PLANNING COMMISSION REPORT
Regular Agenda – Public Hearing Item

PC Staff Report
05/21/14

ITEM NO. 9B: SPECIAL USE PERMIT; INSTITUTIONAL DEVELOPMENT PLAN; 2900 & 2920 HASKELL AVE (SMS)

SUP-14-00110: Consider a Special Use Permit for an Institutional Development Plan for the Lawrence College and Career Center, located at 2900 & 2920 Haskell Ave (east of the proposed relocated Haskell Avenue). The project proposes the construction of a new two-phase structure containing 56,000 sq. ft. and associated parking and site improvements. Submitted by Landplan Engineering PA on behalf of Unified School District 497, property owner of record.

SUP100

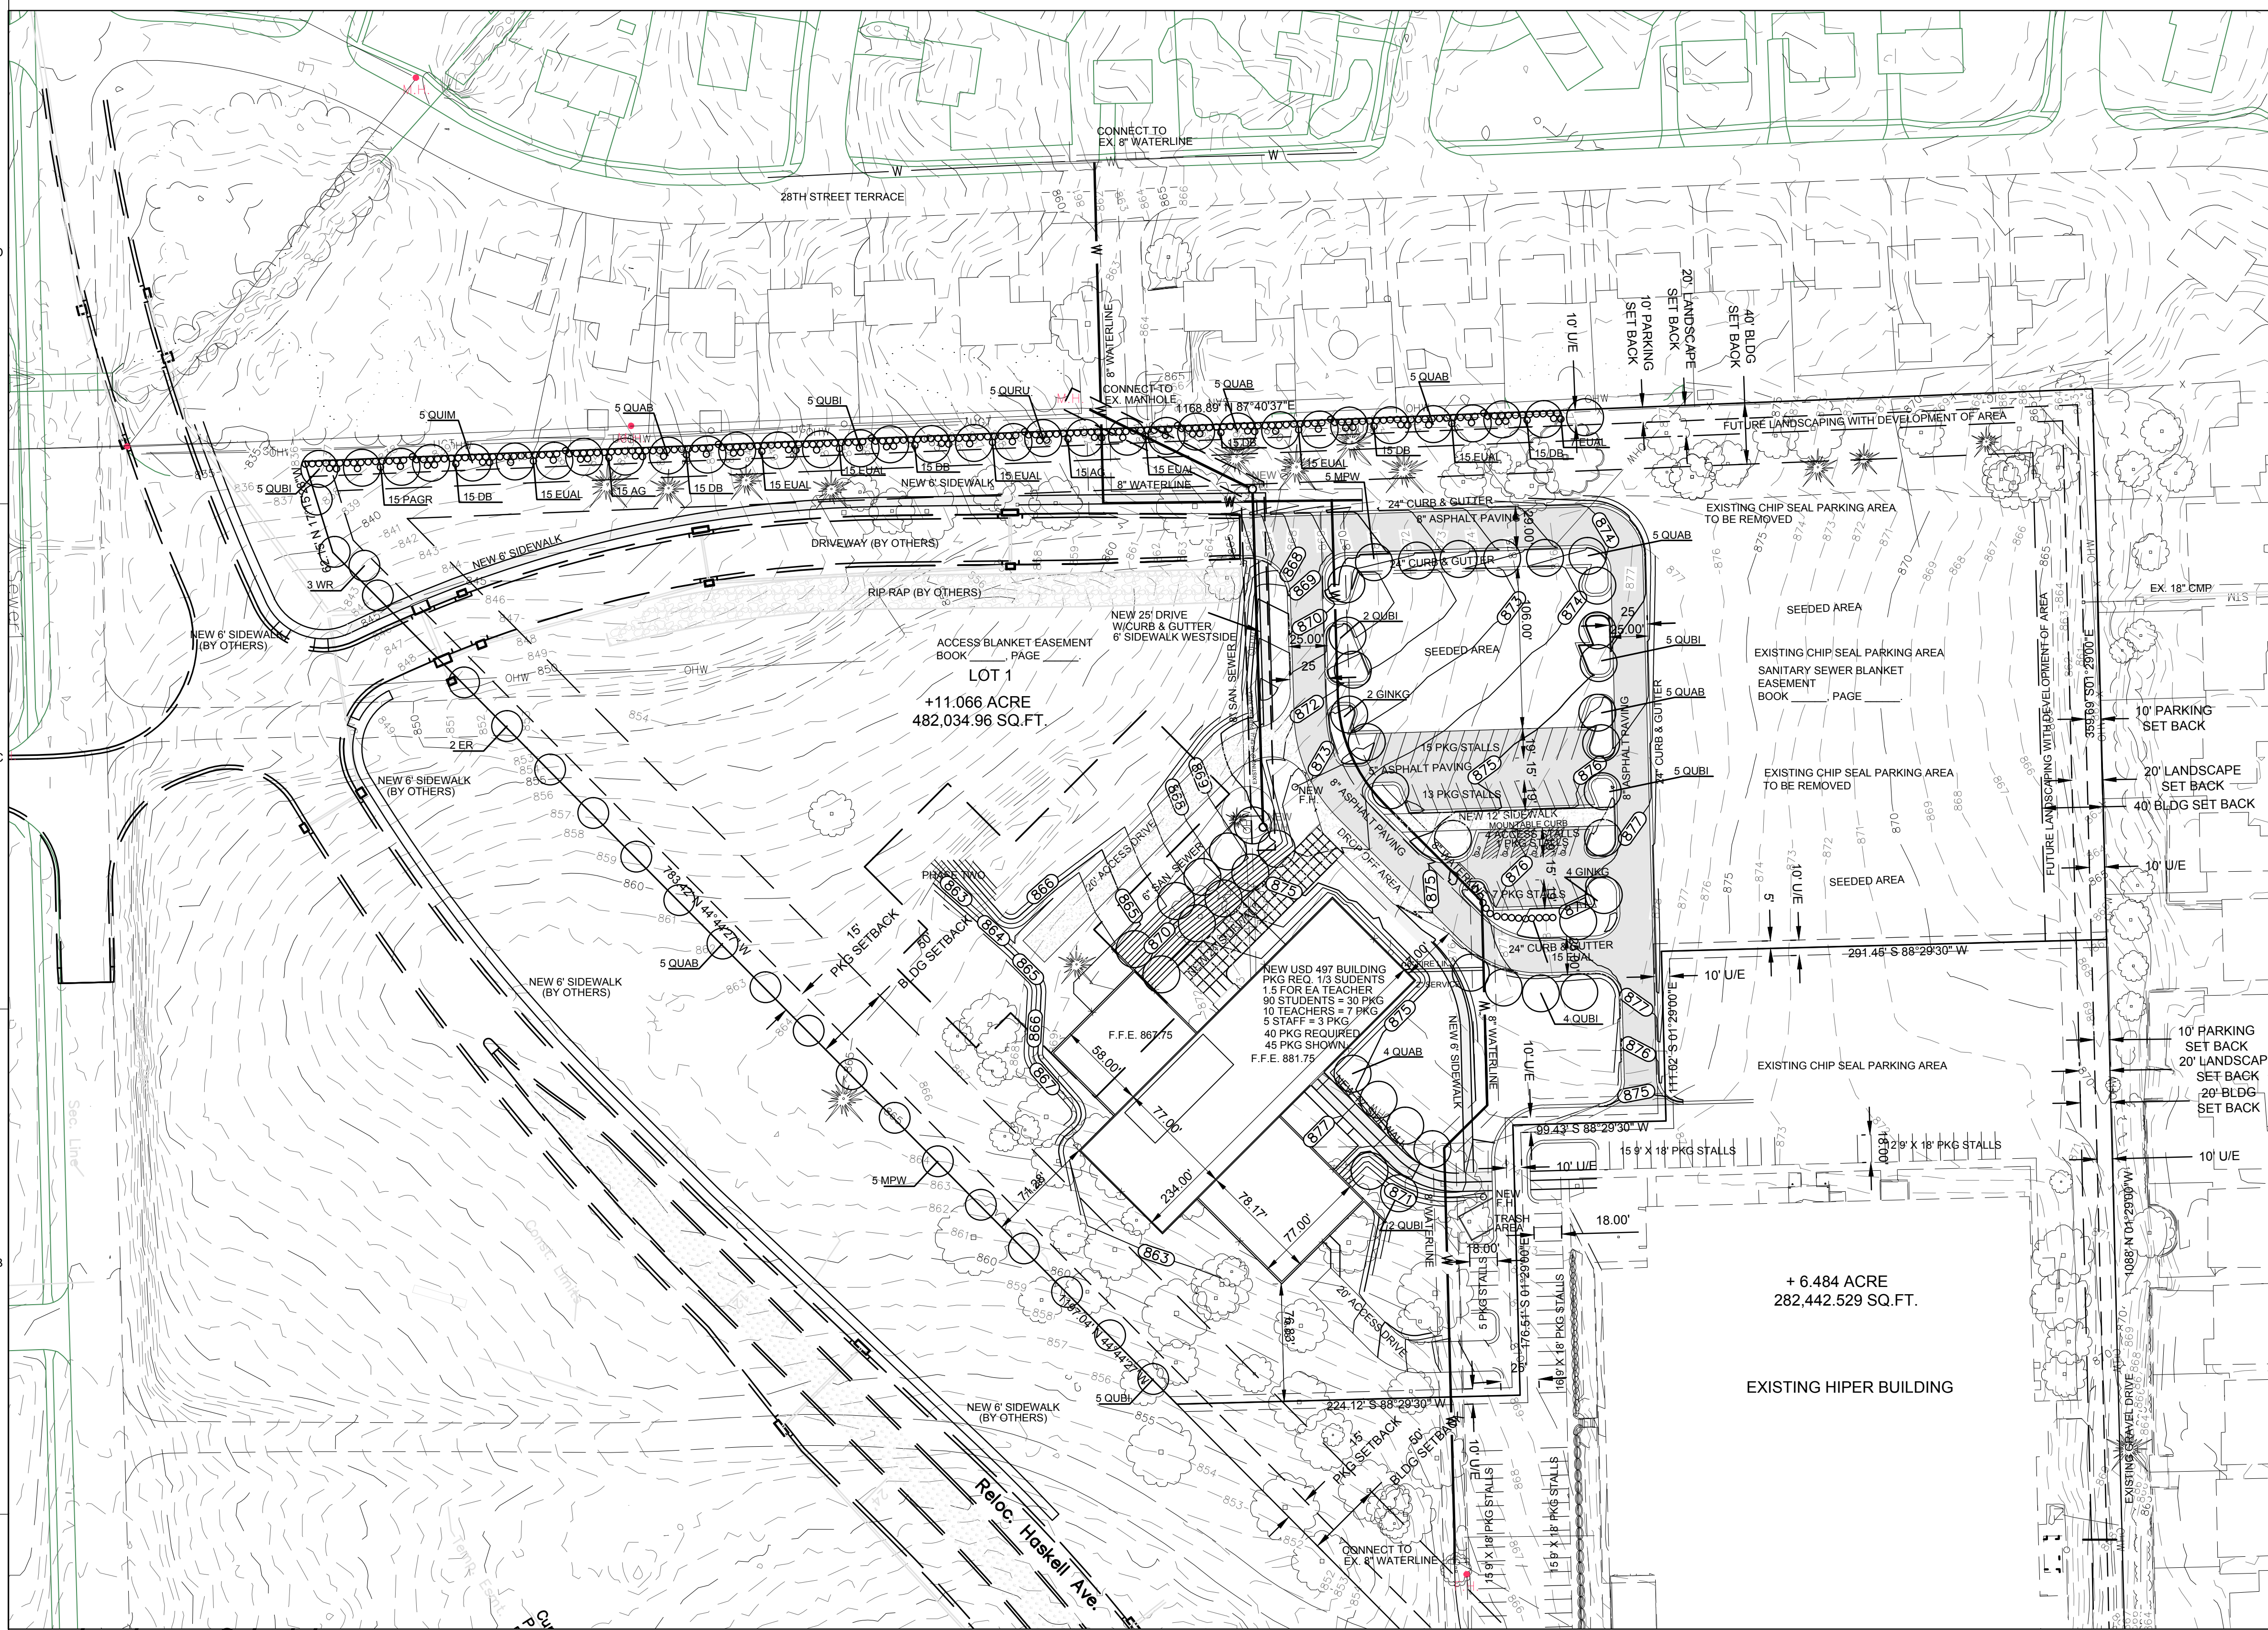
1. Applicant shall provide a revised site plan with the following changes:
 - a. Graphically show the dedicated cross access easement provided from Haskell Avenue to proposed Lot 2.

- b. Graphically show the dedicated utility easement for the existing sanitary sewer service line that connects the existing EDC building with the sanitary sewer main along the north property line.

- c. Provide a note that indicates that either a temporary asphalt curb or wheels stops will be provided along the north edge of the Phase 1 northernmost parking bay.

- d. Provision of an exhibit that identifies the extent of Phase 2 improvements and a note on the plan that indicates subsequent site plan revisions to the Institutional Development Plan may be processed administratively.

- e. Provide a note on the plan that states lighting fixtures shall be provided with a full cut-off fixture and be directed down.
2. Review and approval of revised plan by City Public Works, Utilities and Parks staff.

The site plan proposes planting a significant number of White Oak and Ginkgo trees. The City's Horticulture Manager has indicated that these are extremely slow growing, expensive and difficult to establish without extensive irrigation. She has provided suggestions to modify the species selection to include plants that are drought tolerant, cold hardy, indigenous to Kansas and contribute to the environmental/wildlife habitat at a reasonable cost to the project. She has suggested alternatives that provide an opportunity for the school site to be part of a learning corridor between the Baker Wetlands and Prairie Park. Modifications to the landscape plan have been requested. *(The applicant has provided a revised plan which addresses some of these comments. Additional review and discussion will be required prior to approval.)*

Buffer Yard Requirements: This property is proposed to be rezoned to the GPI District. Section 20-1307(c)(2)(i)(a) requires provision of a Type 2 Buffer Yard for educational sites. The plan identifies a 40' wide building setback and 20' wide landscape setback along both the north and east sides of the property abutting the adjacent residential areas. Trees and shrubs are proposed along approximately two-thirds of the northern boundary to screen the initial phase of development. The plan indicates future landscaping will be provided along the remainder of the north boundary and the eastern boundary with future development. Staff has notified the applicant that additional shrubs may need to be added to fill in gaps in the existing tree line along the north boundary if headlights become an issue.

Additional details regarding the site lighting are required. The applicant intends to use building mounted lighting for this site. All lighting fixtures will need to be directed down and be provided with a full cut-off. A photometric plan and review of lighting fixture details is required to be provided for staff review and approval prior to issuance of a building permit.

A public street is stubbed south of E 28th Terrace to the north boundary of this site. However, due to the anticipated community-wide draw, it does not seem appropriate to connect this site directly to the adjacent local neighborhood streets. Approval of the SUP plan should include a waiver from the requirement to provide two separate vehicular access points to the site.

future instead of extension of the sanitary sewer main all the way south to the existing building. An administrative waiver will need to be approved for this request before the Special Use Permit and plat can be completed. The applicant has indicated that a blanket sanitary sewer easement will be dedicated. The Utilities Engineer has indicated that the service line must be field verified and a specific utility easement dedicated for that location.
